MOSSMAN COMMUNITY INFRASTRUCTURE UPGRADES RESPONSE TO REQUEST FOR INFORMATION

On behalf of our client, Department of Aboriginal and Torres Strait Islander Partnerships, with reference to the Confirmation Notice & Information Request (OP2417/2017), we provide the following responses to your request (*in blue italics*) for your consideration.

1020 – Mossman Gorge Community Infrastructure Upgrades

Water Reticulation

BOOSTER PUMP CONNECTION (IF ORDERED)
SCALE 1:25

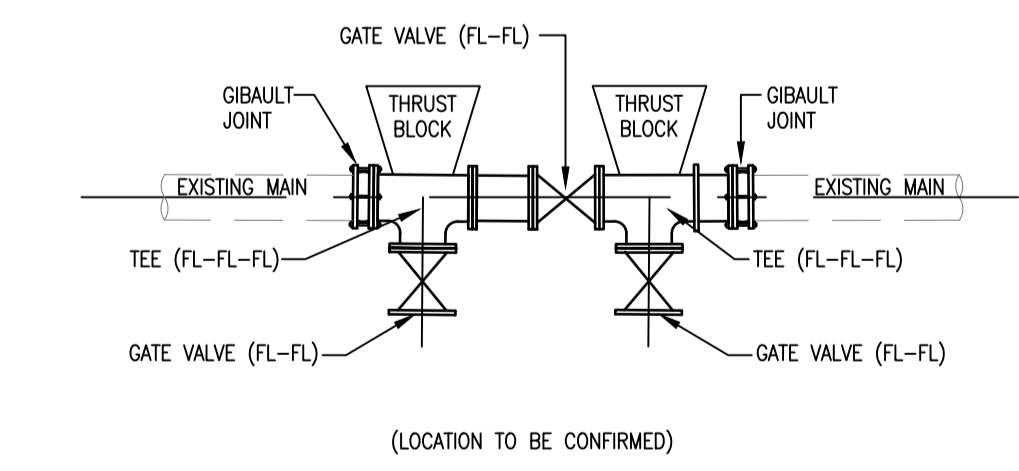
Confirmation whether a booster pump station is required. The determination of the booster pump is to have regard to the results of the water supply network analysis.

In summary a booster pump station may be installed if Council requires that all FNQROC guidelines are to be met.

A booster system is not recommended due to the requirement for ongoing maintenance (electrical and pump based). A booster will only be required to provide additional residual pressure to the system during a firefighting event and with the cumulative effects of all conservative assumptions applying concurrently. That is, a QFES fire tender is drawing flows higher than 12.9 L/s; and the community demand is 2/3 of PH flows; and the reservoir is not full; and the pipe roughness is at C=100 (not C=110 as calibrated from hydrant flow tests). In all other reasonable situations, the booster will remain dormant.
